## TOLEDO - LUCAS COUNTY PLAN COMMISSIONS

REF: SUP-3001-22

TO: President Matt Cherry and Members of Council, City of Toledo  
FROM: Toledo City Plan Commission, Thomas C. Gibbons, Secretary  
SUBJECT: Special Use Permit for a School at 3912 Sunforest Court

Request	-	Special Use Permit for a Day Care Center
Location	-	5045 W. Sylvania Avenue
Applicant	-	Hossein Elgafy 5045 W. Sylvania Avenue Toledo, OH 43606
Owner	-	Toledo Muslim Community Center 3319 Nebraska Avenue Toledo, OH 43607
Engineer	-	Sam Muhsen Buehrer Group 314 Contant Street Maumee, OH 43537

# SITE PLAN

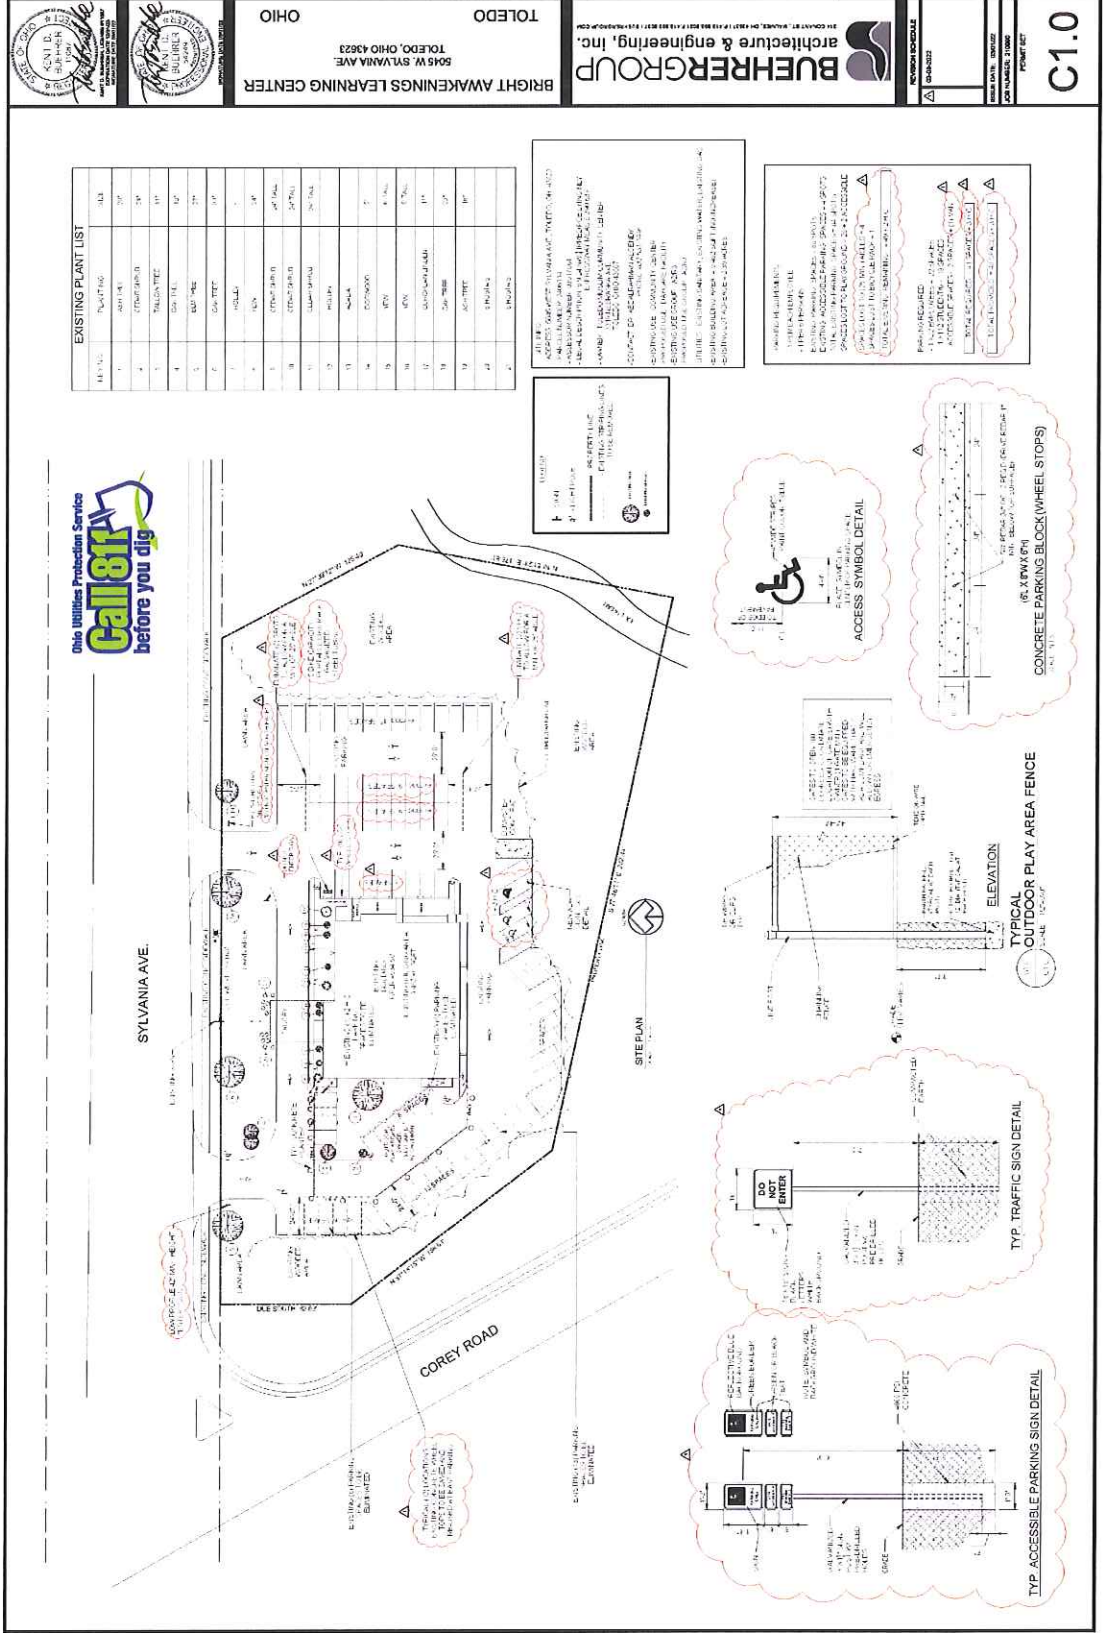
- a. A portion of the parking area will be removed and reconfigured to accommodate the outdoor play area.
- b. The use requires 24 parking spaces and 51 are provided. The site exceeds the 150% allowable maximum for parking spaces at 220%. However, the site is existing and is reducing the total number of spaces bringing the site closer into compliance.

- a. The reuse of an existing site is not required to comply fully with current landscape standards, but must bring the site closer to compliance.
- b. Staff is requesting a 7' Type B landscape buffer be installed along the 225' perimeter of the outdoor play area in place of the proposed planters with the pavement removed.

7. A 7' Type B landscape buffer shall be provided along the perimeter of the outdoor play area. The 225' area requires 9 trees and 34 shrubs. A privacy fence may substitute for the shrub requirement. **Shall be indicated on a revised site/landscape plan.**

8. Dumpsters shall be screened from view and may not be located in any required setback or landscape buffers and as far from residential areas as possible. Fencing details shall be provided. **TMC 1108.0203.G. Shall be indicated on a revised site/landscape plan.**

9. Planting details shall be provided such as the type, size, and quantity of plantings. **Shall be indicated on a revised site/landscape plan.**
10. **Landscape areas shall be indefinitely maintained.** Landscaped areas may not contain bare soil, aggregated stone or decorative rock. Any ground area must be covered with hardwood mulch, grass or other vegetative ground coverage.
